**Re: Archaeological Evidence – Kauri Cliffs, Waiaua Bay Farm Limited**

# Initial Ecological Advice for the Plan Change Proposal for Kauri Cliffs Special Purpose Zone

### HIGH LEVEL GEOTECHNICAL REVIEW TO SUPPORT S42A REPORT, PROPOSED REZONING OF KAURI CLIFFS

## **SUBMISSION 463 - WAIUAU BAY FARM LIMITED - KAURI CLIFFS**

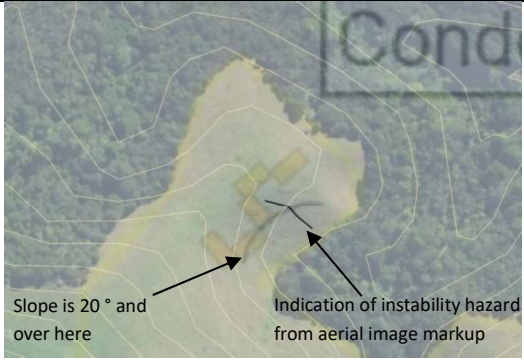
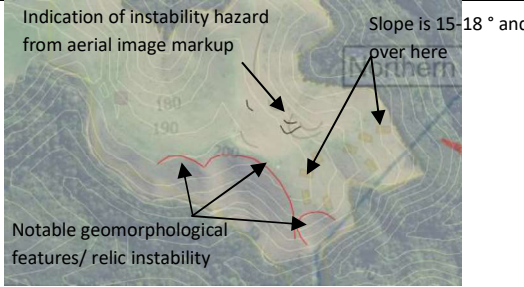
Mapping	Review	Recommendations
 <p>Slope is 20 ° and over here</p> <p>Indication of instability hazard from aerial image markup</p>	<p><b>Condominium.</b> Overlay of instability features from aerial mapping places the feature through the development. LiDAR 1 m contours indicate that the Condominium development is formed on slopes of up to and marginally over 20 ° inclination. This exceeds the recommendations of the T&amp;T report detailed above and indicates the Condominium will be formed on land defined as subject to natural hazards. The development is also away from the recommended ridgeline location.</p>	<p>The Condominium development should be further assessed in terms of suitability in this location and supplemented by geotechnical assessment such as investigation and slope stability model if the proposal continues to be placed in an area that exceeds the recommendations of the T&amp;T report.</p>

<p>Indication of instability hazard from aerial image markup</p> <p>Slope is 15-18 ° and over here</p> <p>Notable geomorphological features/ relic instability</p>	<p><b>Northern Cluster.</b> The proposed northern cluster is placed over slopes which exceed the T&amp;T recommendations and are considered subject to instability. Red lines indicate significant, notable</p>	<p>As currently proposed, the northern cluster development should be further assessed in terms of suitability in this location and supplemented by geotechnical assessment such as investigation and slope stability model if the</p>

<p>geomorphological features which may indicate deep seated movement. The T&amp;T report is silent on these features which may indicate instability potential beyond their defined outline that encroaches within the northern cluster. Further, the proposed road alignment trends through these feature which increase to 25 to 30 degrees in slope gradient.</p>	<p>proposal continues to be placed in an area that exceeds the recommendations of the T&amp;T report. Assessment of the significant geomorphological features should be presented including potential deep seated mechanisms. A stable zone outside of these features should be established.</p>
	<p><b>Southern Cluster, Residential Sites and Village</b> This area of the development is indicated over the broad ridgeline which has shallower slopes consistent with the T&amp;T report. This area is expected to represent the volcanic flows over the top of underlying Waipapa Group. However the volcanics are indicated to stop around the edge of the bush line which drops away at significantly steeper gradients than anticipated by the T&amp;T review. Being similar geology to the northern cluster, there are also major instability and relic features noted in these areas from review of LiDAR contours.</p>	<p>The T&amp;T report is silent upon the steeper gradients through the bush and focusses upon the gradients over the building area only. The steeper sloping bush clad areas and landslide features will have a zone around them that do not meet adequate factors of safety for development. It is recommended that further analysis is undertaken to determine appropriate offset zones to meet the T&amp;T recommendations for stable land.</p>
